From:	Eric Sugalski <eric@bostondevice.com>
Sent:	Tuesday, May 3, 2011 4:29 PM CDT
To:	Andy Moskowitz <andymoskow@gmail.com>
CC:	David Schoon <dschoon@bostondevice.com>
Subject:	Fusion Device Review
Attachments:	110503 Flexispine Review.pdf, 110503 fusion wedge.EASM

Flexispine Review – 05/03/11

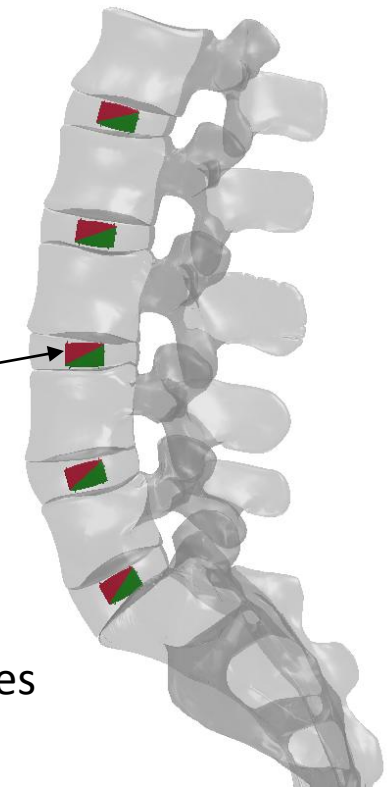
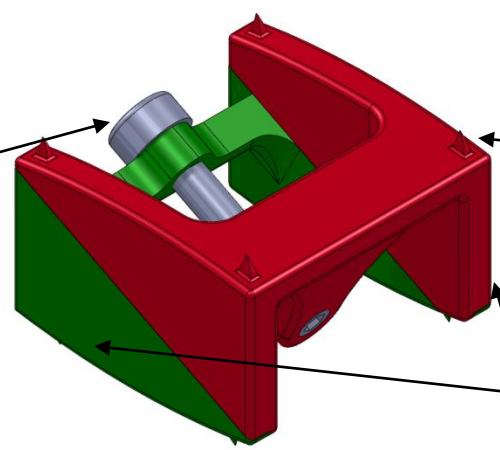
- Flexispine Posterior Lumbar Fusion Device
  - Retaining screw inline with device motion.
  - Rounded “bullet” shape.
  - Adjustable fit for lumbar region of spine

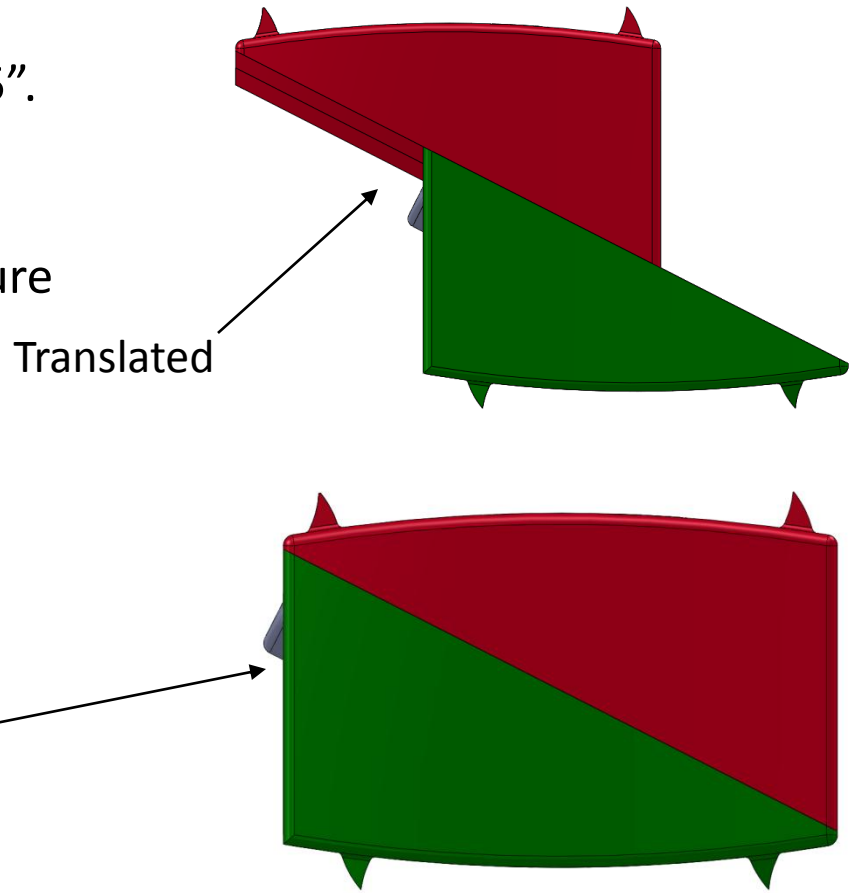
- Flexispine Posterior Lumbar Fusion Device
  - Traction tooth height ~.035”.
  - Height min .359”
  - Height max .471”
  - Fixed height devices measure .406”
  - Device length .5”, after translation .75”
  - Width .512”

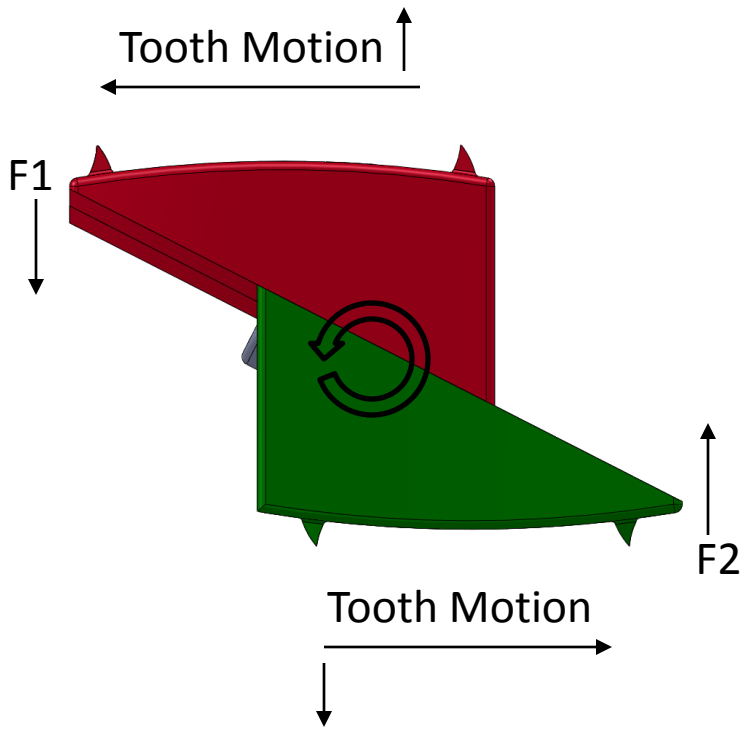
- Flexispine Posterior Lumbar Fusion Device
  - Teeth move horizontally and vertically. Would drag against bone.
  - Translating body can be unstable dependent upon load conditions.

SCISSOR JACK

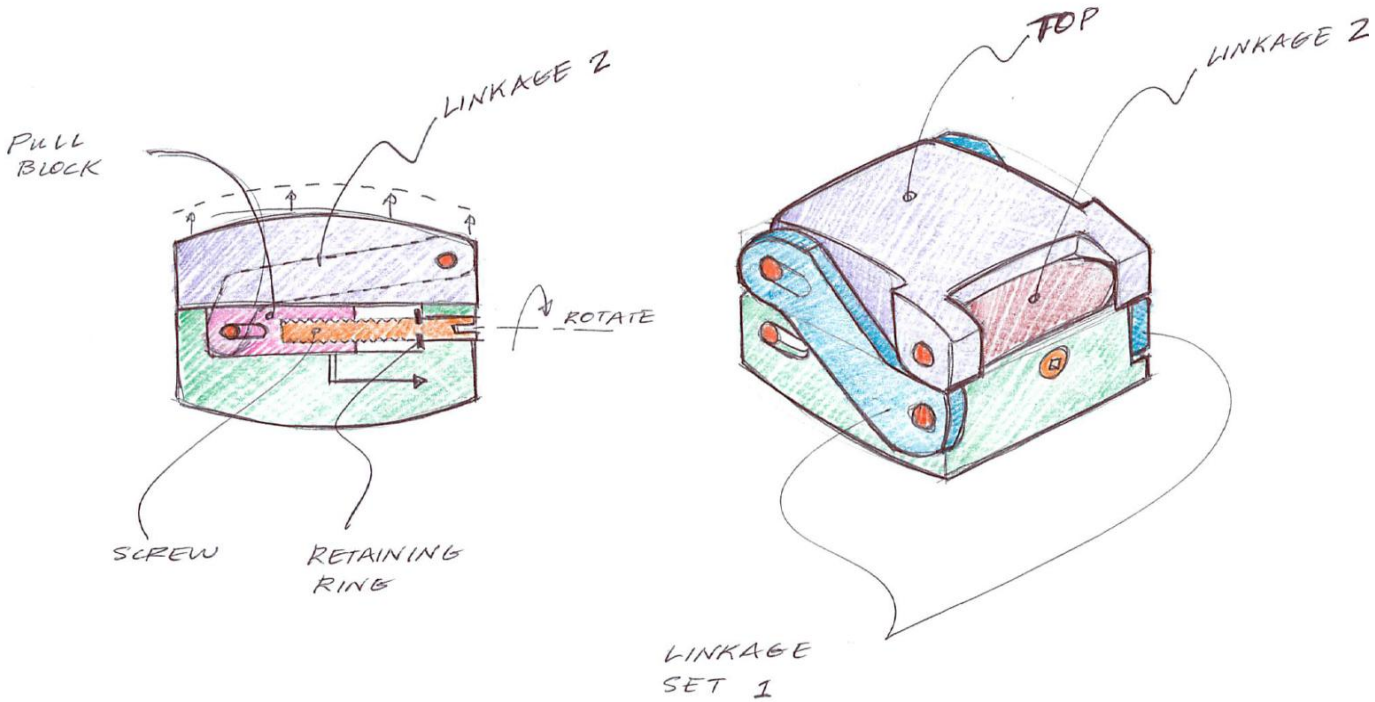
* SCREW DRIVES PULL-BLOCK WHICH FORCES LINKAGES TO EXPAND. TOP & BOTTOM SEPARATE IN PARALLEL MOTION.

DRYWALL ANCHOR

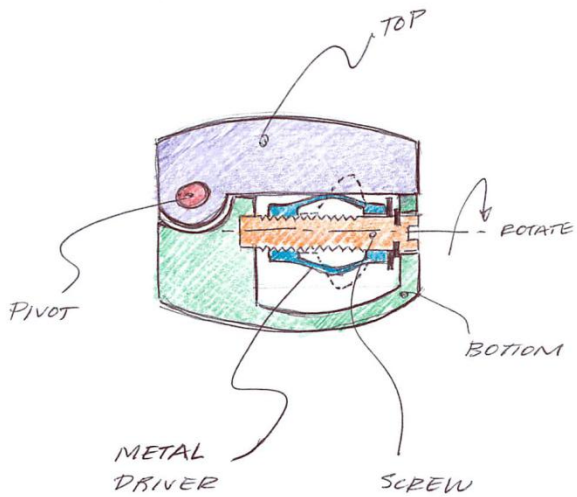
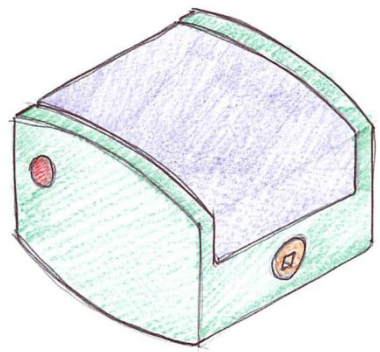
AS SCREW IS ROTATED, METAL DRIVER BUCKLES AND EXPANDS RADIALLY. THIS FORCES TOP TO PIVOT AWAY FROM BOTTOM.

MODIFIED WEDGE

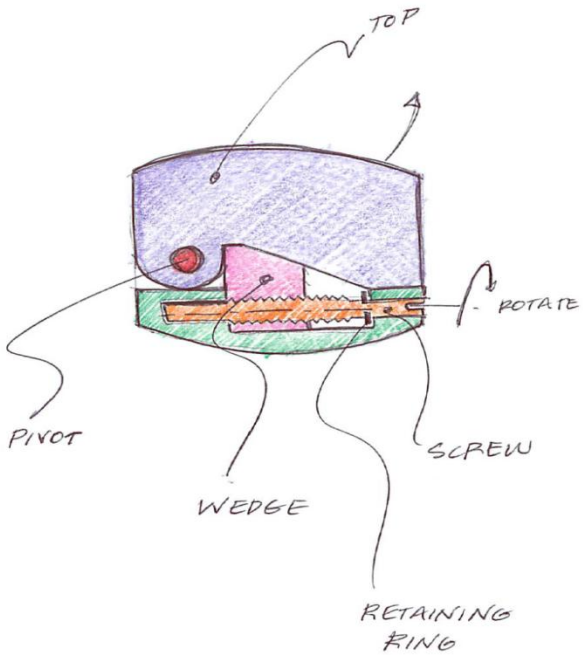
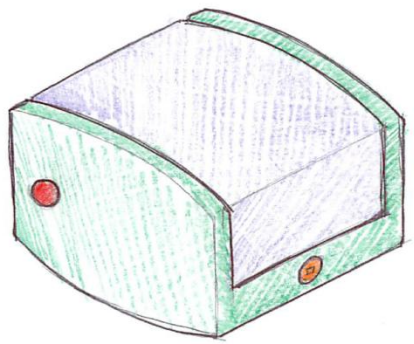
USER ROTATES SCREW, WHICH DRIVES WEDGE AXIALLY, FORCING TOP TO PIVOT UPWARD
